RECOMMENDED SERVICE BULLETIN**NUMBER:** SB14-11**REVISION:** 01**DATE:** 04/13/2016**SUBJECT:** POROUS PANELS FLOW – CAV ICE PROTECTION SYSTEM**EFFECTIVITY**

SERVICE BULLETIN
S.B.13002-XX-30-001

REWORK OF FLUID INLET FITTING
WITH CORRODED SET-SCREW

Figure 1. View of Inlet Connector Showing Corroded Set Screw

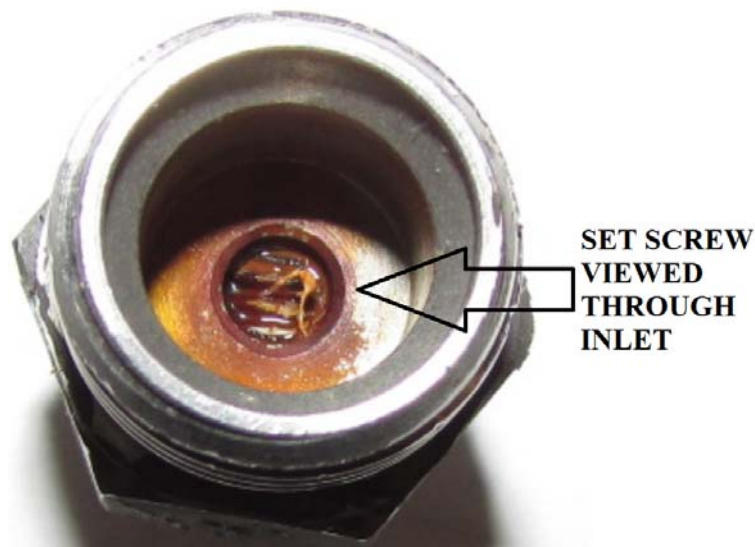
- (1) Gain access to the Porous Panel inlet connector by (Refer to AMM).
- (2) Inspect set screw through inlet connector using mirror and/or light source if required. Check for signs of corrosion/rust (ref. Figure 1).
- (3) If signs of corrosion exist carry out procedure according to Section 3.B. If no corrosion is evident, this Service Bulletin has been complied with, and no further action is required.
- (4) Refit pipeline. Restore aircraft in accordance with AMM.

- (1) If set screw shows signs of corrosion unscrew entire inlet connector from Porous Panel and remove from aircraft.
- (2) Inspect the inlet connector to establish whether the set screw has been set during factory calibration. If the set screw is not fully across the bore it

Figure 2. Test Set-Up

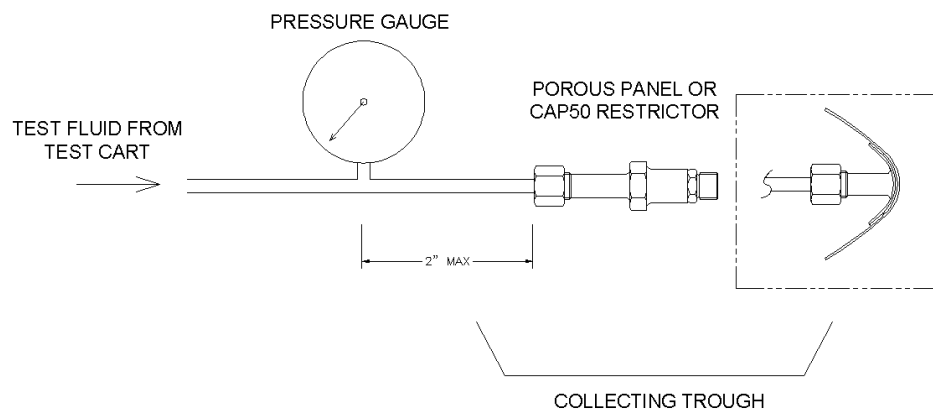
- (3) Fill Test Cart with Test Fluid.
- (4) Verify test set-up and fluid viscosity by connecting Test Cart outlet tube to the CAP50 calibrated restrictor with the pressure gauge teed in at a location upstream of and close to the restrictor (ref. Figure 1). Apply fluid to the restrictor at 3 +/- 0.1 psi. Using a measuring cylinder of an appropriate range collect fluid over a timed period of 1 minute to obtain the flow rate. Confirm this flow rate is 50ml/min +/- 5%. If this flow rate is not achieved, check fluid viscosity and test set-up. Revise fluid mixture and/or test set-up and re-check flow rate through restrictor until required flow rate is obtained.

NOTE: The length of tube between pressure gauge inlet and Panel/restrictor inlet should be no more than 2". Ensure gauge is positioned level with the inlet.
